DPW Offices and Garage

Town of Sudbury ADA Transition Plan

October 2020

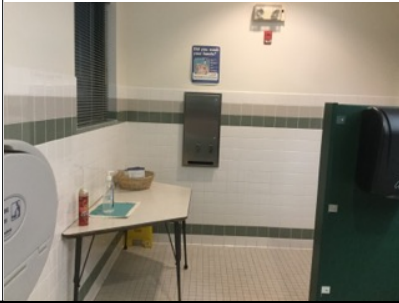
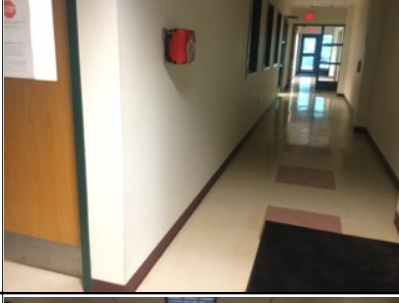
- Recommend increasing lighting outside of the engineering office so that signage is more legible.
- Recommend providing a designation sign with raised characters and braille at the engineering conference room.
- Recommend providing an accessible charging station. The ADA Standards do not include specific provisions for electric vehicle (EV) charging stations. However, it is advisable to address access to EV charging stations so that they are usable by people with disabilities. See the following diagram:

- Provide a 3' wide min. striped accessible route on both sides of the vehicle space that connects to the charging station for easier access.
- A vehicle space at least 10' – 13' wide is advisable. A 10' width offers an extra 2' that effectively provides a 5' aisle on one side when paired with the accessible route; a 13' wide space will allow an 8' aisle. This flexibility is helpful since the parking direction is determined by the location of the charging station and the vehicle connection. Use the International Symbol of Accessibility (ISA) only where

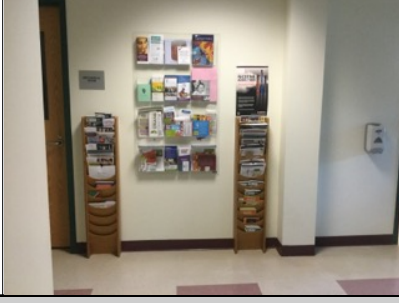
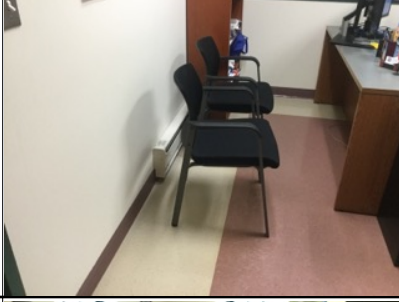
8	Corridor by Main Entrance	1		Interior Access Route	N/A		Obstructed by protruding objects	5"	Relocate or recess fire alarm box.	1	256	\$256
9	Application Forms Area/Overlook	1		Interior Access Route	N/A		Obstructed by protruding objects	41.5"	Provide a cane-detectable barrier on the open side of the high counter.	1	306	\$306

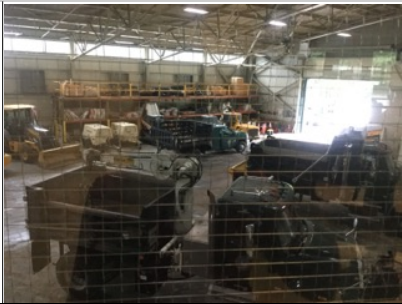
24	Conservation	1		Dining or Work Surfaces	Work Surface		Clear floor space not provided at work surface	37"	Relocate desk so that there is 48" clear min.	1	Labor	\$0
